MEYDENBAUER CENTER ROOF REPLACEMENT (BARREL ROOF)

ADDENDUM #01 FEBRUARY 19, 2025

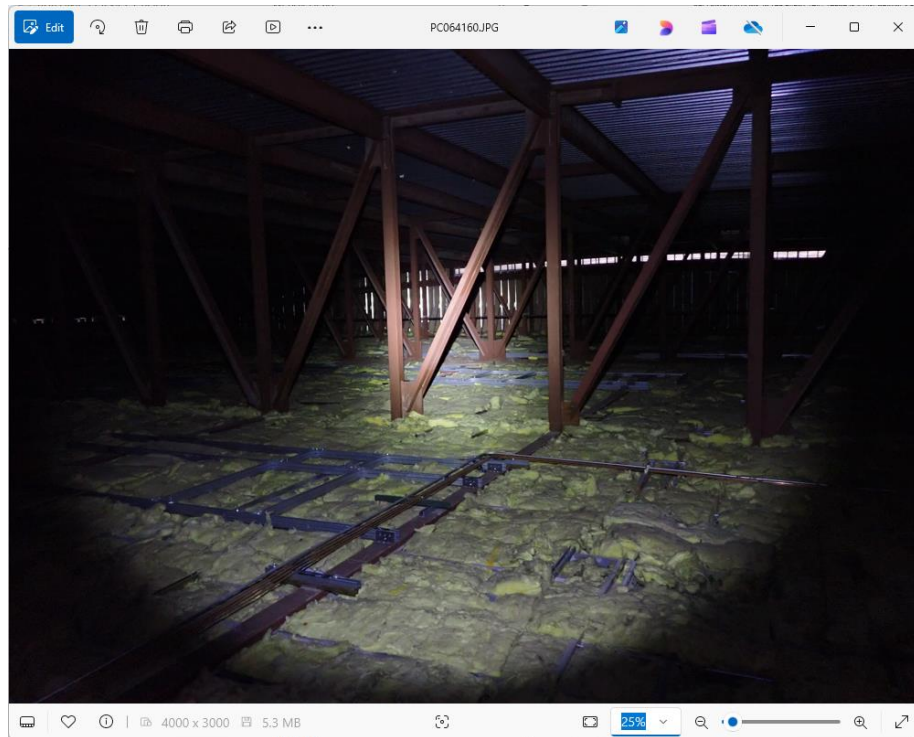
6. Sheet A-000 Paragraph D.2 describes an alternate to increase the attic batt insulation from R-30 to R-49. The bid form does not reflect this alternate. Is this alternate void? If not, can we inspect the attic space for this alternate work prior to bid?

Answer: Yes, The insulation scope is part of the alternate. At this point access to the attic space will not be available prior to the opening of bids. For referenced see below photo of interstitial/attic space
